**SYDNEY WATER
BUILDING PLAN APPROVED -
SUBJECT TO REQUIREMENTS**

Sydney Water Tap in™ Ref No: 2040235

Building/Structure Description: Proposed New Dwelling

TITLE	SITE PLAN	
SHEET	A001	A3 SCALE As indicated
PROJECT	PROPOSED NEW DWELLING WITH POOL, ASSOCIATED SITE WORKS. DEMOLITION OF EX'G DWELLING	
CLIENT	GEORGE & LAURA AITKEN	
ADDRESS	11 LOCH ST, FRESHWATER LOT 2 IN D.P. 14040

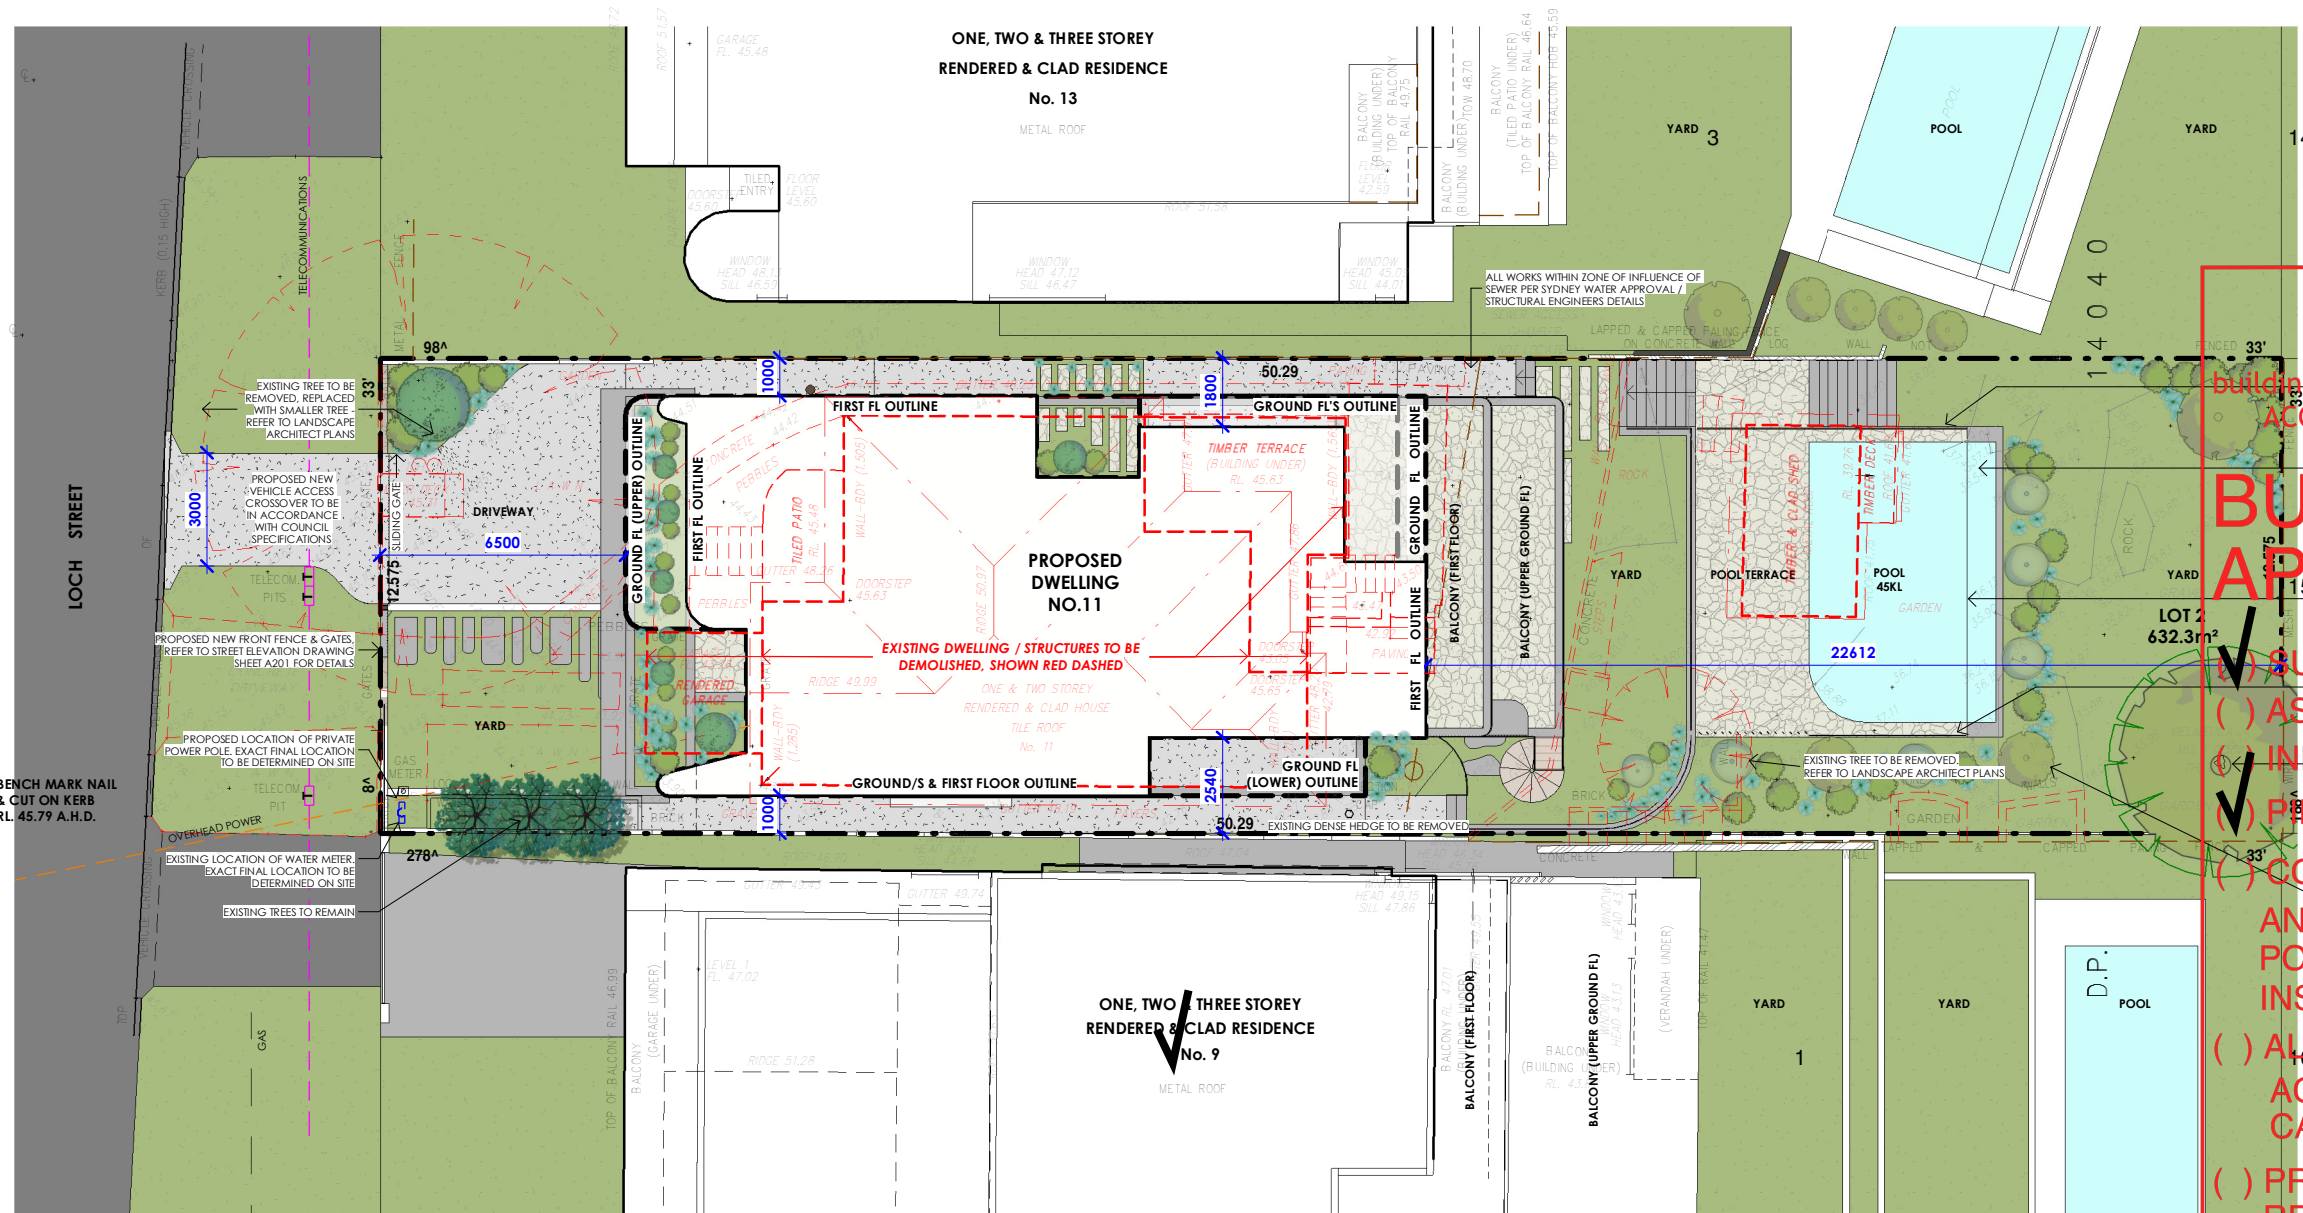
Proposed building/structure is APPROVED to construct OVER/ADJACENT TO a Sydney Water asset, subject to the following requirements:

1. The foundations/piers are to be founded below the zone of influence or to solid rock.
2. No part of the building/structure or its foundations to be less than a minimum 900mm, horizontal distance from the outside edge of the asset.
3. No part of the below ground building/ structure/foundations to be less than 600/900mm horizontal distance from the outside edge of any Sydney Water Structure.
4. Foundations/piers are constructed in accordance with Engineers detail plans (stated above) as submitted to Sydney Water.
5. Sydney Waters Asset to maintain no less than 450mm of ground cover.
6. No part of the above-ground building/structure to be less than 600mm horizontal distance from outside edge of any Sydney Water structure.

(A) Please allow 48 hours to book in the pier inspection

Above requirements must be inspected/supervised by a WSC to enable the issue of a satisfactory compliance letter.
